SUBJECT: HOLTEC INTERNATIONAL'S APPLICATION FOR SPECIFIC INDEPENDENT SPENT FUEL STORAGE INSTALLATION LICENSE FOR THE HI-STORE CONSOLIDATED INTERIM STORAGE FACILITY FOR SPENT NUCLEAR FUEL – FIRST REQUEST FOR ADDITIONAL INFORMATION, PART 5

First Request for Additional Information, Part 5

Docket No. 72-1051

Application for specific independent spent fuel storage installation license for the HI-STORE Consolidated Interim Storage Facility in Lea County, New Mexico

Figure 2.1.2: HI-STORE CIS Facility Site Boundaries [2.1.3]

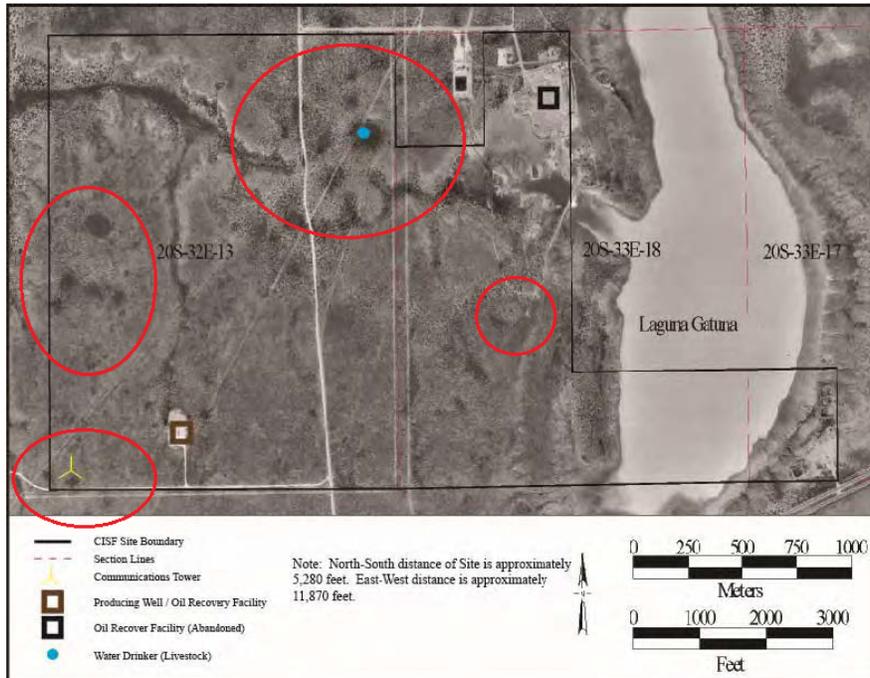
Section 2.2.2 of the SAR, "Pipelines," states that an oil/gas producing well exists at the proposed site. The SAR Figure 2.1.2 also shows a producing well in the southwest corner of the facility.

Explain the origin of the features circled in red in Figures 2.1.2 and 2.1.5, particularly with respect to dissolution of the Capitan Reef or other subsurface carbonate and evaporite deposits either through natural process or human activities. Also, assess the future potential for similar surface deformation as a result of natural processes or human activities in the site area.

Figure 2.6.2 of the SAR shows the site is underlain by over 1,000 feet of the Capitan Reef, a carbonate formation in the site region that is well-known for the large-scale karst features that have developed at the surface and at depth. Most notable of these features is the Carlsbad Caverns, approximately 65 miles southwest of the site. The staff also notes the presence of additional carbonate and evaporite rocks both above and below the Capitan Reef and the association of subsurface halite dissolution above the Capitan Reef with several sinkhole features in southeastern New Mexico. Additionally, SAR Figures 2.1.2 and 2.1.5 show numerous circular features throughout the site and surrounding areas but the application does not discuss the origin of these features. On Figures 2.1.2 and 2.1.5, these features are indicated by red circles. The green box on Figure 2.1.5 is the general outline of the area covered by Figure 2.1.2.

Figure 2.1.5: Aerial View of the Site (Full Build-Out) [2.1.8]

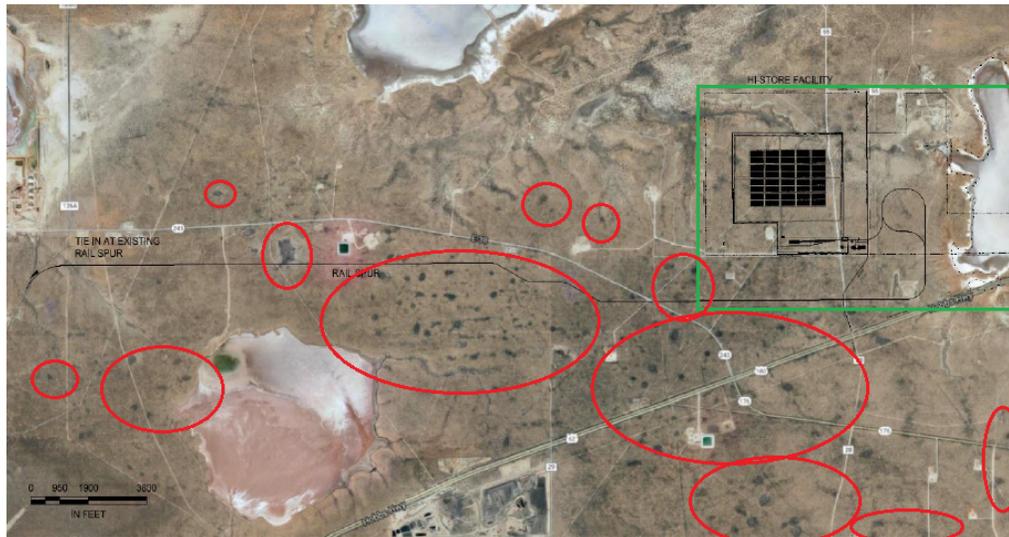
RAI 2-22: Provide additional information describing the proposed rail track and embankment that will connect the proposed CISF with the existing railway spur (SAR Figure 2.1.5). The information should include elevations of railroad embankment, any hydraulic structures incorporated into the embankment, and design parameters of the hydraulic structures if applicable. Also, provide information on the likelihood of failure for the rail track and embankment during extreme weather events, e.g., a PMP, and the effect of such failure to the flooding of proposed CISF on-site structures, systems, and components.

Section 2.1.2 of the SAR stated that “aerial view of the site is shown in Figure 2.1.5 and several plot views of the HI-STORE CIS Facility with all phases complete are shown in Figures 2.1.6(a), (b), and (c).” Figure 2.1.5 of the SAR indicates that a rail track is proposed to connect the proposed CISF to an existing rail spur to the west of the site. Figure 2.1.6(a) of the SAR indicates that the proposed rail track will run between the proposed CISF and Laguna Gatuna but does not provide the elevation of the rail track and any potential hydraulic structure incorporated into the railroad embankment.
